The foregoing amendments are made pursuant to a telephone interview between the undersigned and Examiner Tse on November 20, 2001.

Applicant requests approval of the amendments to FIGS. 1, 4 and 9 shown in the Request for Approval of Drawing Changes being filed concurrently herewith. These changes are basically being made to clarify that FIGS. 4 and 9 show in more detail one of the complex signal paths of the front end of FIG. 1. Corresponding amendments are also being made in the written description.

VERSION TO SHOW CHANGES MADE

FIG. 1

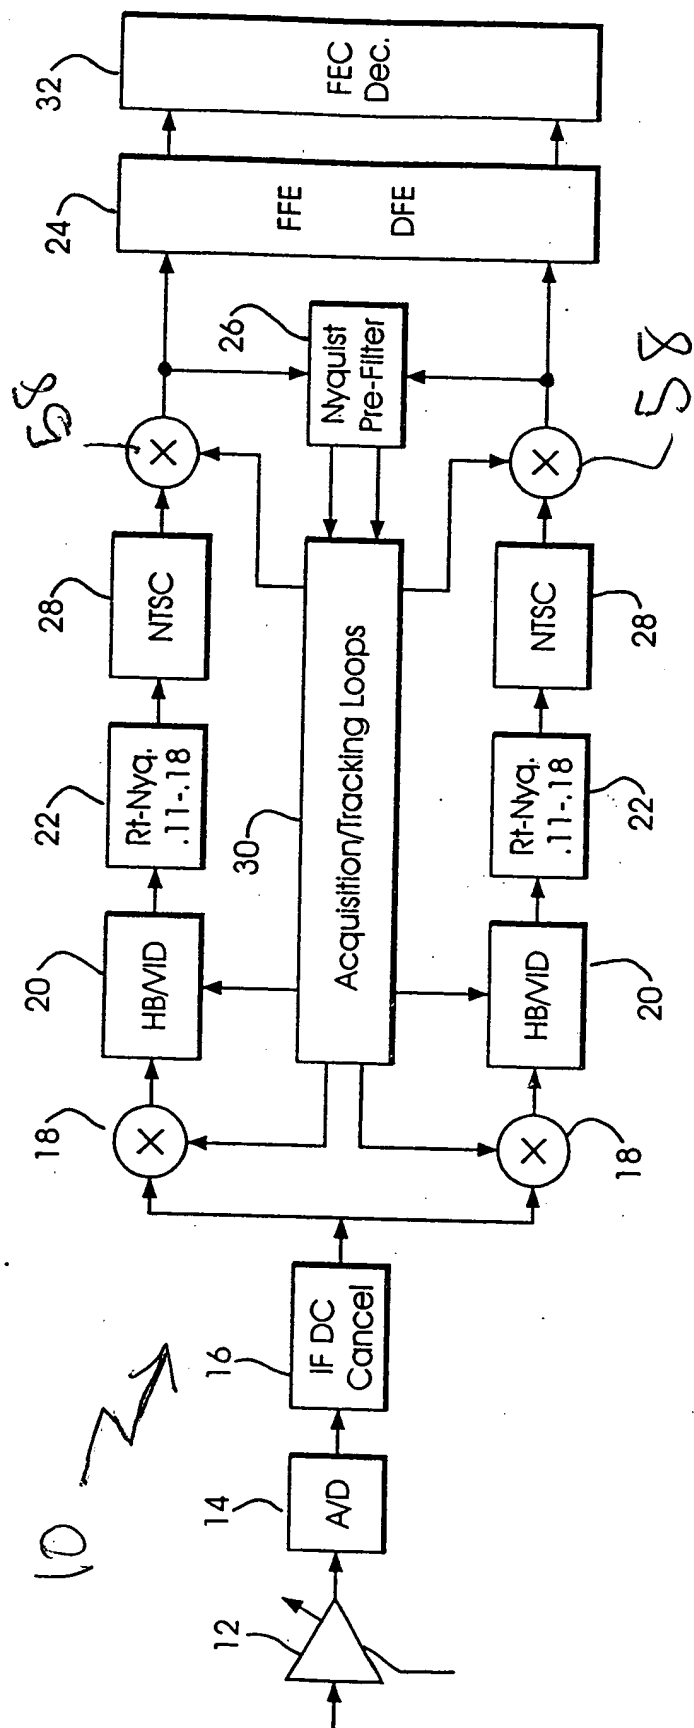
In the pending Office action, claim 10 was rejected under 35 U.S.C. § 112, first paragraph, as containing subject matter not described in the specification. The foregoing amendments to the written description and drawings clarify how they corresponds to claim 10. Specifically, the front end comprises elements 12, 14 and 18 in FIG. 1. The first tracking loop, which is represented by block 30 in FIG. 1, comprises blocks 66 and 70 in FIG. 4. The second tracking loop, which is also represented by block 30 in FIG. 1, comprises block 68 and 72 in FIG. 4. The third tracking loop, which is also represented by block 30 in FIG. 1, comprises blocks 76, 78 and 80 in FIG. 4.

In-phase (I) and quadrature phase (Q) baseband signals are then filtered by square-root Nyquist filters 22 which can accommodate roll-off factors of 11-18%. The outputs of the square-root Nyquist filters are subsequently directed by a complex digital mixer 58 to an adaptive equalization block 24 and are parallel-processed by a Nyquist-type prefilter 26 to provide an input signal to an acquisition/tracking loop circuit 30 which includes carrier recovery loop circuitry to support carrier frequency recovery and spectrum centering as well as baud recovery loop circuitry,

for symbol timing extraction, as will be described in greater detail below. A carrier frequency recovery control signal produced by circuit 30 is applied to an input of mixer 18. A spectrum centering control signal from circuit 30 is applied to an input of mixer 58. The baud recovery control signal from circuit 30 is applied to HB/VIB 20 to sample the signal from mixer 18.

FIG. 4

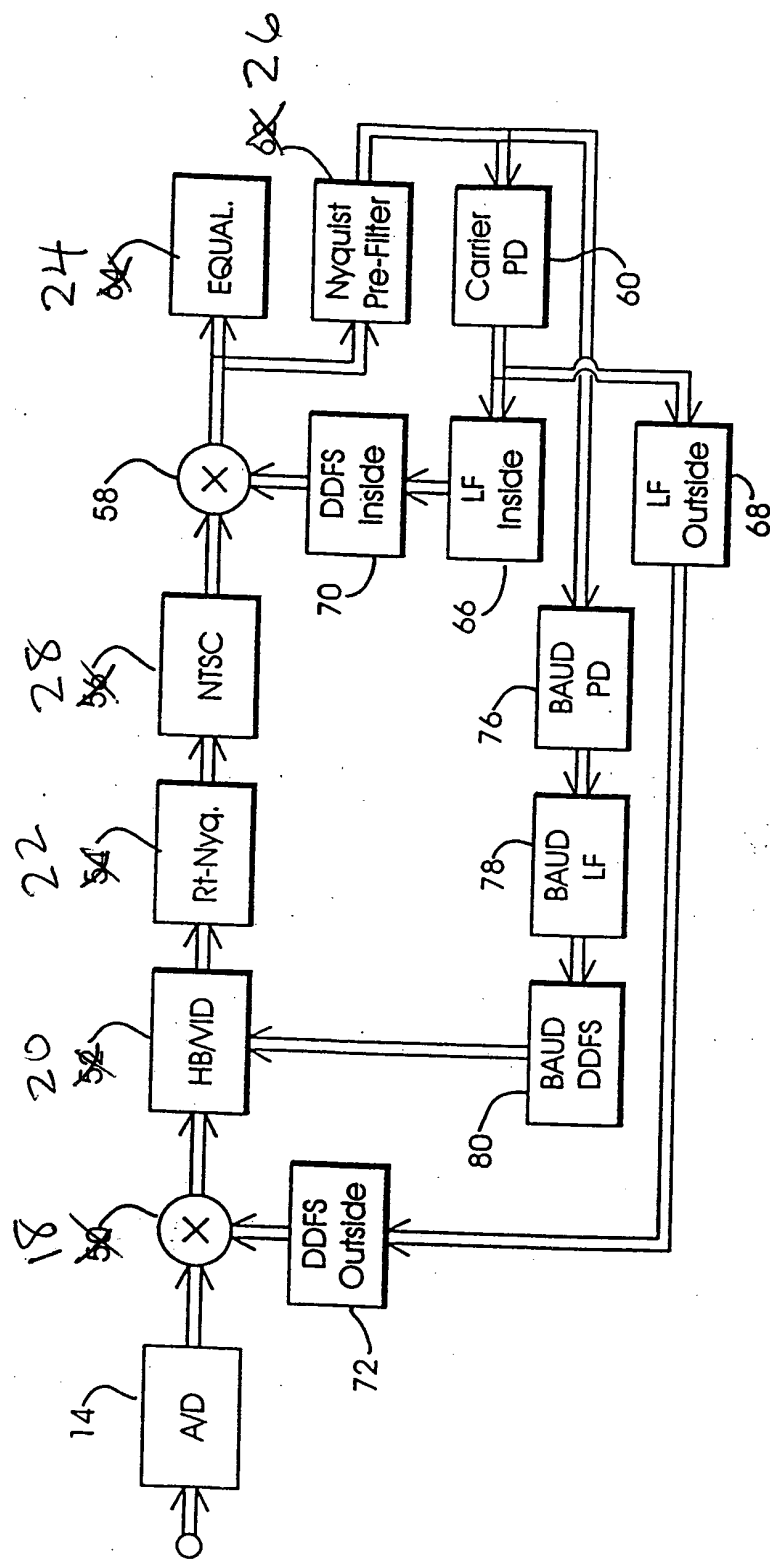
FIG. 4 is a [simplified, semi-schematic] more detailed block diagram of the architecture of [carrier recovery and baud loops of a dual mode QAM/VSF receiver in accordance with the invention] FIG. 1;

Turning now to FIG. 4, there is depicted in detail, one of the complex signal paths of the front end architecture described in FIG. 1, illustrating the acquisition/tracking loops comprising circuit 30. [in simplified, semi-schematic block diagram form, an exemplary embodiment of a unitary carrier and recovery and symbol timing loop architecture, termed] This arrangement can be regarded as "unitary" in that both functions, frequency acquisition and tracking and symbol timing (also termed "baud recovery") are operable in response to the pilot (unsuppressed carrier) signal. In the embodiment of FIG. 4, an input IF spectrum is digitized by an analog-to-digital converter (A/D) and the resulting digital complex signal is directed to a complex mixer 50 where it is combined with a complex signal having a characteristic frequency f_C equal to the carrier frequency. The resulting complex signal is processed by a highband filter and variable rate interpolator, represented as a single processing block in the embodiment of FIG. 4, and denoted HB/VID 52. In a manner to be described in greater detail below, symbol timing is performed by a baud loop coupled to provide symbol timing information to the variable rate interpolator (VID) portion of the HB/VID filter 52. Following interpolation, baseband IF signals are processed by a square root Nyquist filter which has a programmable roll off α of from about 11 to about 18%. The square root Nyquist filter 54 is further designed to have a particular cutoff frequency that has a specific relationship to the VSB pilot frequency f_C , when the VSB spectrum centers at DC. In a manner to be described in greater detail below, this particular cutoff frequency is chosen to have this particular relationship in order that both carrier recovery and symbol timing recovery might be based on a VSB pilot frequency enhancement methodology.

FIG. 9

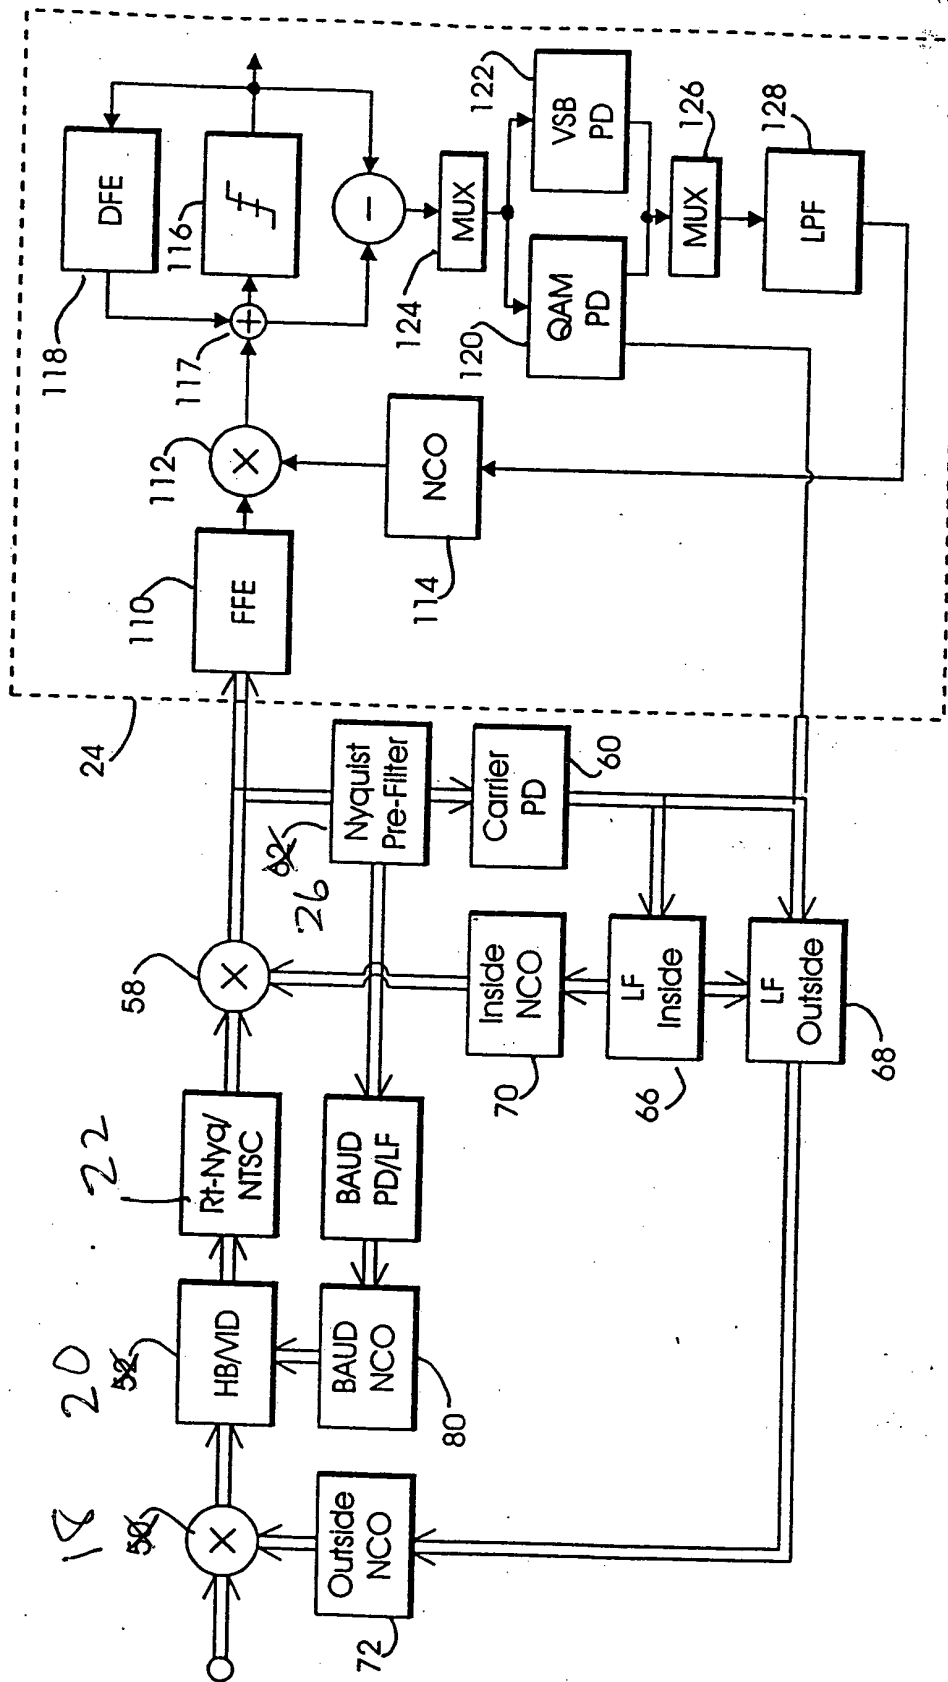
FIG. 9 is a simplified, semi-schematic block diagram of a dual mode QAM/VSF receiver architecture, including the decision directed carrier phase tracking circuitry [in accordance with the invention] of FIG. 4;

Turning now to FIG. 9, there is depicted a simplified, semi-schematic block level diagram of one of the complex signal paths of the front end of FIG. 4 incorporated in a dual mode baseband architecture. [of the exemplary] A dual mode QAM/VSB receiver, [including] includes details of the construction and arrangement of adaptive equalizer 24 having decision directed VSB phase tracking and decision directed QAM frequency acquisition and phase tracking loops in accordance with the present invention. As illustrated in the embodiment of FIG. 9, the adaptive equalizer includes a feedforward (FFE) block 110 configured to receive symbol aligned complex signals centered in baseband. The FFE 110 is suitably constructed as either a 64-tap real FFE, for VSB applications, or a 16-tap complex FFE when used in connection with QAM modulated signals. Carrier phase alignment and/or carrier frequency/phase alignment is performed in a mixer 112 which receives signals from the FFE 110 and combines them with a timing reference signal developed by a timing reference circuit 114 such as a numerically controlled oscillator (NCO) a voltage controlled oscillator (VCO) or a direct digital frequency synthesizer (DDDFS). Timed signals are then provided to a slicer 116 operating in conjunction with a decision feedback (DFE) block 118 which, in combination, provide hard decision information on constellation states as well as error information relating to differences between actual signal trajectory relative to an ideal signal trajectory.
